RE: DENDROBIUM MINE – DPIE-WATER RESPONSE TO EIS SUBMISSION

In response to DPIE's letter dated 20 April 2020, please find enclosed (Enclosure 1) South32's responses to residual concerns raised by DPIE-Water in its submission on the *Dendrobium Mine – Plan for the Future: Coal for Steelmaking EIS* (the Project).

RESPONSE TO DPIE-WATER COMMENTS

Figure 1 – Predicted vs Observed Mine Water Inflow at the Dendrobium Mine

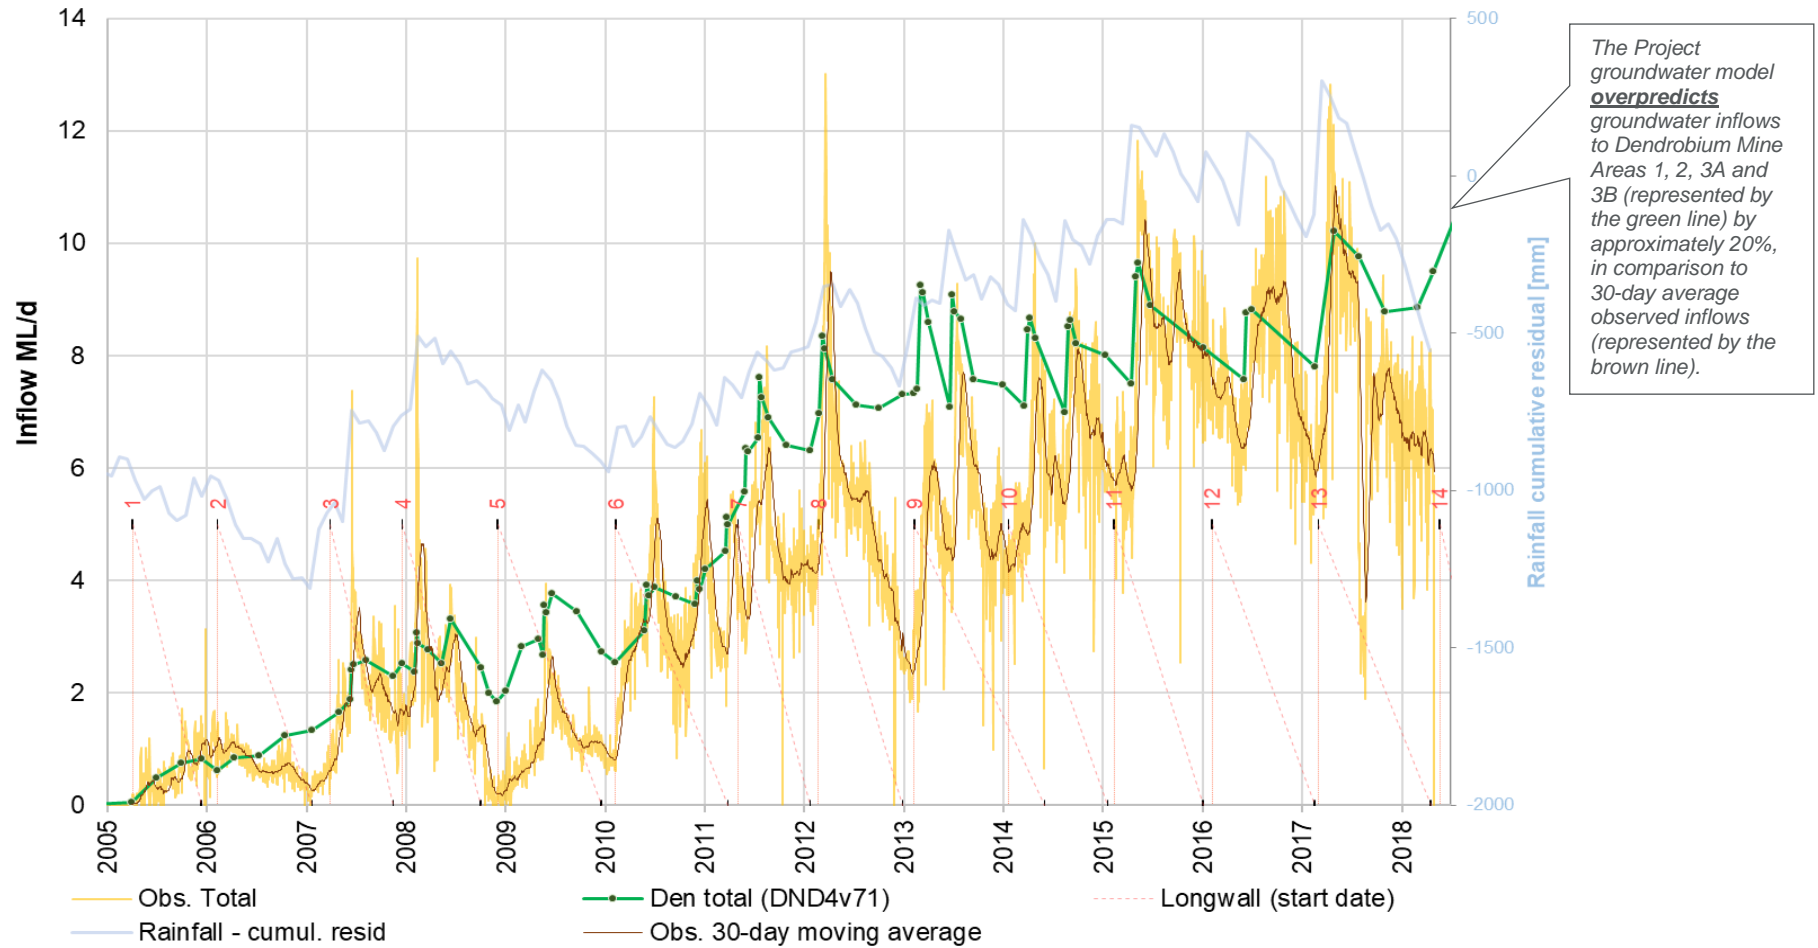
- *The model-calculated mine inflows achieve a better match with mine inflows calculated using other methods. Because the mine inflow data used as calibration targets are not direct (real) measurements (but are derived from a calculated water balance), they should be given less weight in the overall model calibration process.*

The calibration statistics for the model demonstrate that drawdown and mine inflows are adequately replicated, and the conservative nature of the model assumptions means the model has a tendency to overpredict total historic mine inflows to Areas 1-3B by approximately 20%, in comparison to the 30-day average observed inflows (Figure 1).

Figure 2 – Aquatic Ecology Survey Locations

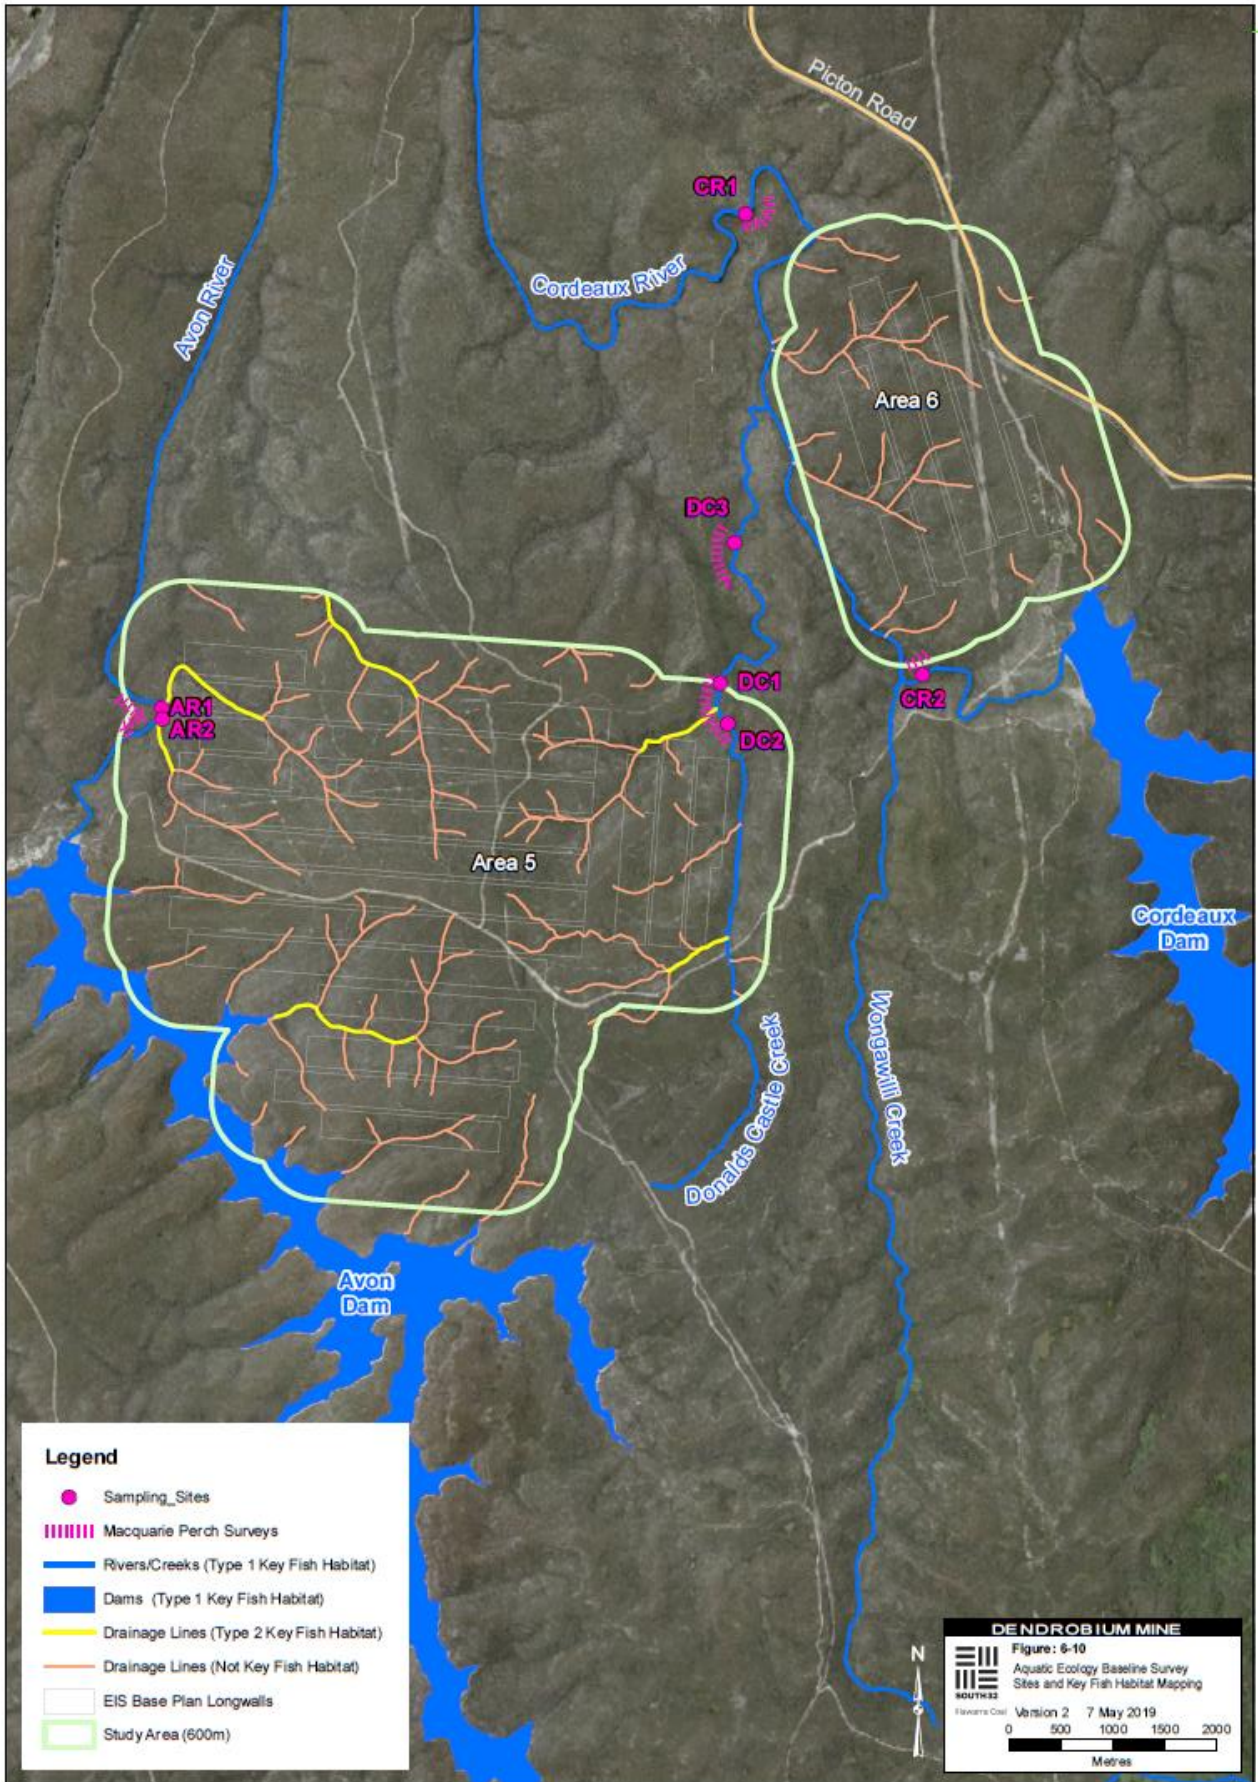
DPIE Water does not consider the advice that the assemblage of macroinvertebrates is impaired due to natural factors has been justified. There is a reasonable likelihood that the assemblage has been affected by other mining activities in the catchment.

The majority of streams located above or proximal to the proposed longwalls are not affected by historical mining (i.e. are not located downstream of historical mining areas). With the exception of survey sites located on Donalds Castle Creek, survey sites located along the Cordeaux River (i.e. CR2) and the Avon River (i.e. AR1 and AR2) are located remote from or upstream of historical mine workings (Figure 2).

Figure 3 – Surface Water Monitoring Locations

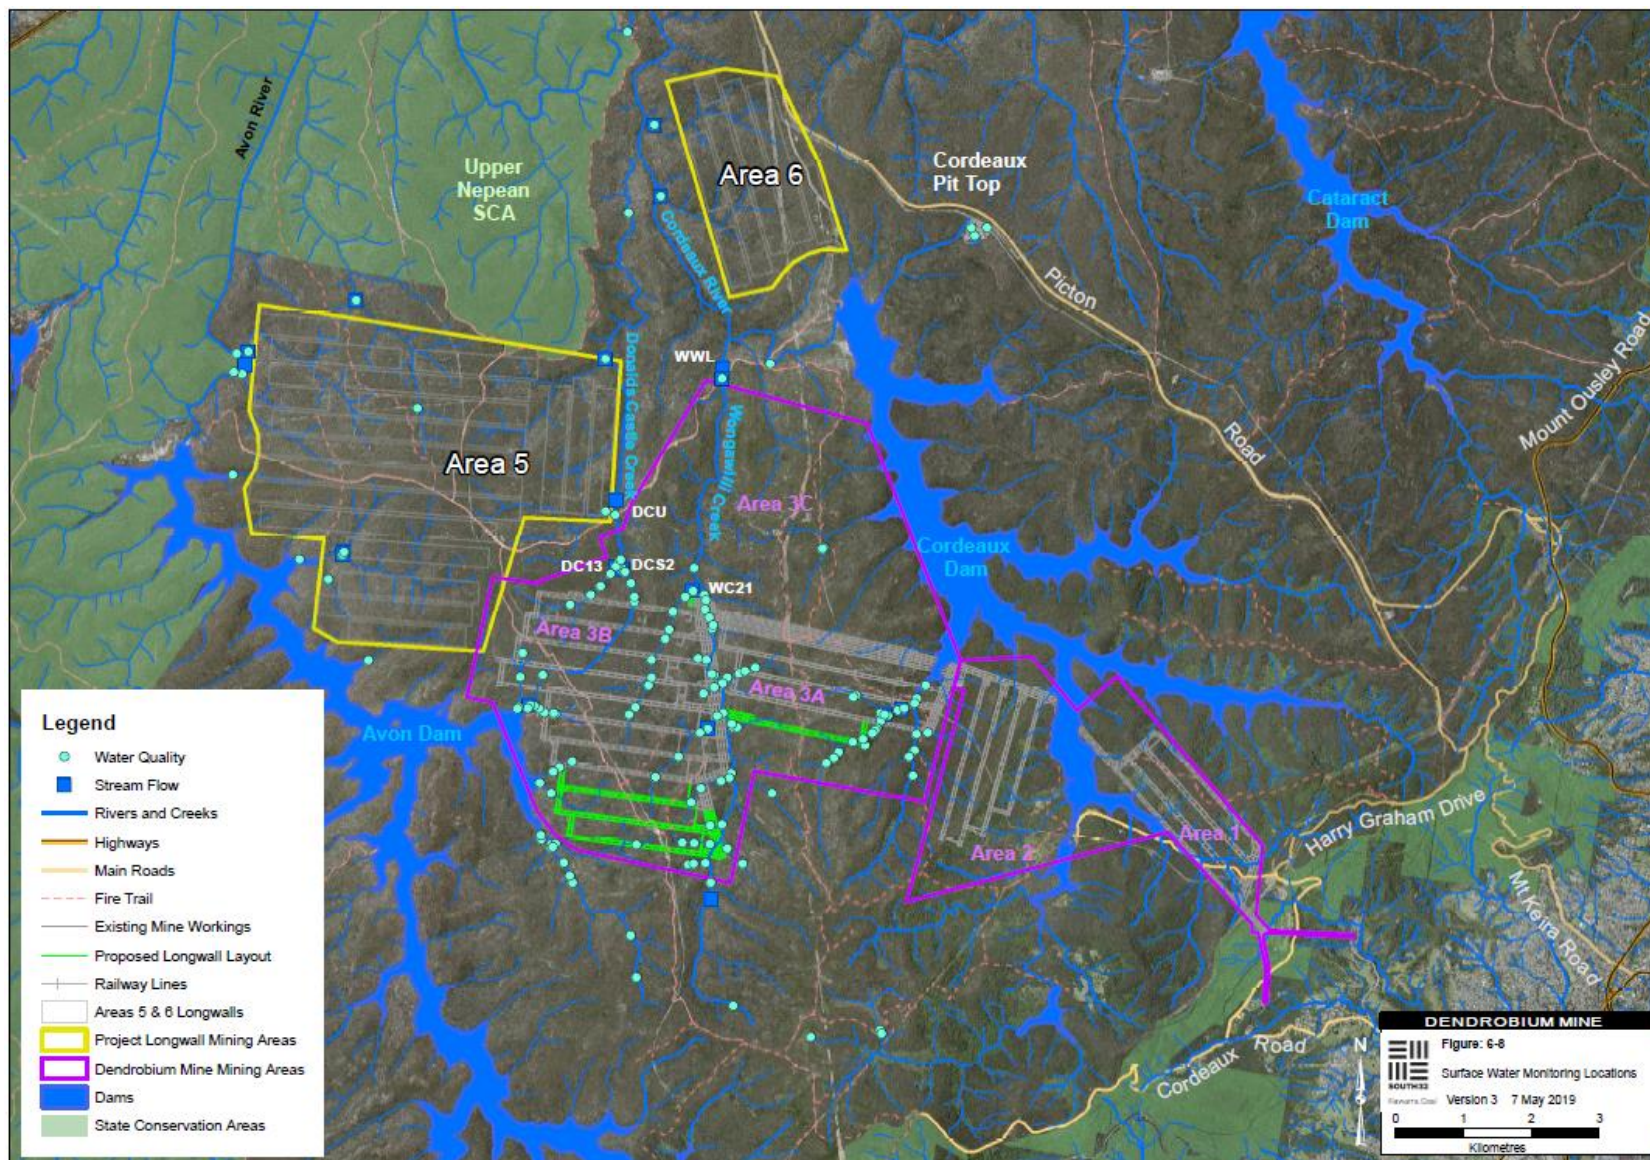
- *A baseline description of existing environment so impacts of reduced baseflow can be monitored. This should include reassessing the macroinvertebrate assemblage using more appropriate methods.*
- *Identification of the closest population of Macquarie perch in the Avon or Cordeaux Rivers.*
- *The monitoring design for macroinvertebrates and native fish to be revised to ensure appropriate baseline is collected.*

In regard to surface water monitoring, South32 maintains a surface water monitoring and management program for the approved Dendrobium Mine (including both surface water flow and quality monitoring). The existing program includes stream flow monitoring of a number of ephemeral drainage lines proximal to Area 5, Area 6 and Donalds Castle Creek (Figure 3).
